STAFF RECOMMENDATION
322 Harvard Ave
June 16, 2021

Application: New Construction - Addition
District: Richland-West End Neighborhood Conservation Zoning Overlay
Council District: 24
Base Zoning: RS7.5
Map and Parcel Number: 104050184.00
Applicant: Van Pond
Project Lead: Jenny Warren, jenny.warren@nashville.gov

<p>Description of Project: New construction of an addition including a ridge raise.</p> <p>Recommendation Summary: Staff recommends approval with the following conditions</p> <ol style="list-style-type: none"> 1. The ridge raise, and any portion of the addition that goes taller than the original house shall be removed; 2. Staff review and approve the final windows, doors and porch roofing color prior to purchase and installation; and, 3. The HVAC shall be located behind the house or on either side, beyond the mid-point of the house, and utility meters shall be located on the side of the building, within five feet (5') of the front corner. Alternative mechanical and utility locations must be approved prior to an administrative sign-off on building permit(s); <p>finding that the project meets II.B of the <i>Richland-West End Neighborhood Conservation Zoning District: Handbook

Figure 2: 2005 dormer addition plans

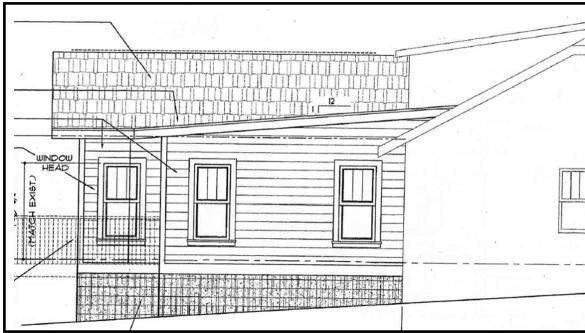
In 2005, staff approved the construction of a modest rear dormer which met the design guidelines and was not visible from the street.

Figure 7: Location of the new Breakfast Room, in blue

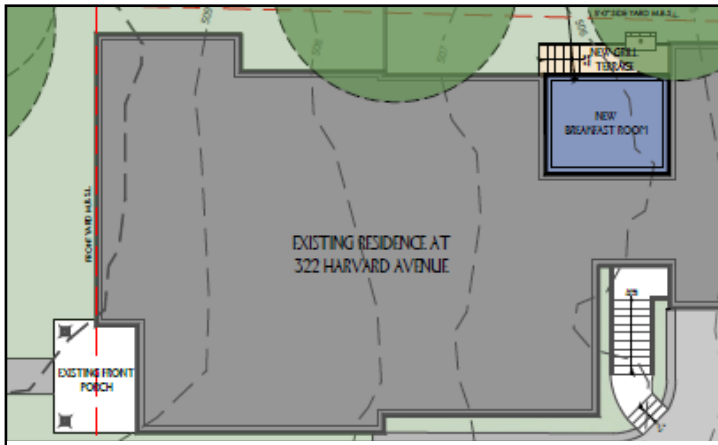
On the left side, a recessed deck area within an existing addition will be enclosed to create a breakfast room. (Figures 7-9) This work will not increase the height or width of the addition. The side wall will be flush with the existing addition, but as this work occurs beyond the appropriate inset from the original back corner, staff finds this to be appropriate.

Figures 8 & 9: Top image is the existing house, note the screened porch at the rear and open porch beneath. Both are enclosed in the proposed elevation on the bottom. Arrow indicates new Breakfast Room

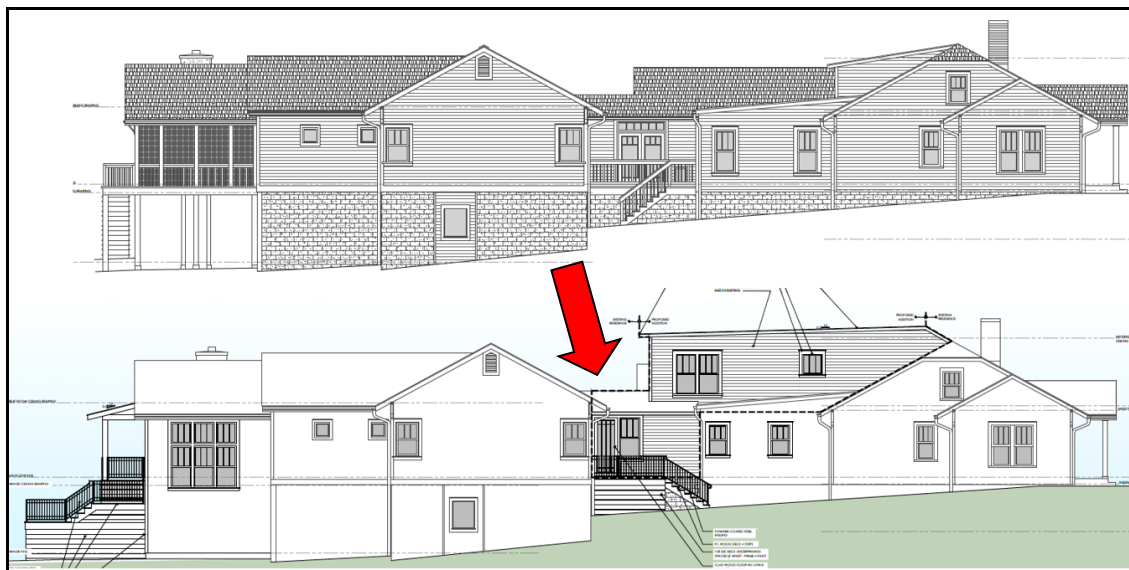
The new construction also includes the enclosure of part of the existing screened porch on the main living level and the full enclosure of a covered porch below into conditioned living space. See Figures 8 & 9. Neither of these alterations will increase the footprint of the existing structure and as such, staff finds this work to be appropriate as well.

A covered rear porch and new stairs will also be added. See Figures 8 & 9. The porch is about forty (40) square feet and is inset from the sides. Staff finds it to be appropriate as well.

Finally, a ridge raise and rear dormer are proposed. See Figures 8 & 9. The ridge raise will step up two feet (2') taller and be inset two feet (2') from the side walls. However, the design guidelines clearly state that *Ridge raises are most appropriate for one-story, side-gable buildings, (without clipped gables)*. Given that this house has clipped gables, staff finds the proposed ridge raise does not meet the guidelines. Further, the additional height and massing - added to a modest historic house that has already tripled in footprint due to prior additions - is not compatible with the historic house. The guidelines only allow for additions that step taller than the historic ridge when there is no other option. This house has a very deep rear yard, and even after three previous additions, there remains more than sixty feet (60') to the rear setback line. Due to the slope of the lot, the previous additions have been able to add an additional level of living space below the main level. Adding further space to the rooftop creates three levels of living space at what was once a modest single-story house. Staff finds that additional rooftop massing stepping higher than the original ridge line is not appropriate in this instance, as other options for additions are available and have been utilized.

With the removal of the ridge raise and rooftop massing, the project meets section II.B.1.a and b.

1. The ridge raise, and any portion of the addition that goes taller than the original house shall be removed;
2. Staff review and approve the final windows, doors and porch roofing color prior to purchase and installation; and,
3. The HVAC shall be located behind the house or on either side, beyond the mid-point of the house, and utility meters shall be located on the side of the building, within five feet (5') of the front corner. Alternative mechanical and utility locations must be approved prior to an administrative sign-off on building permit(s);
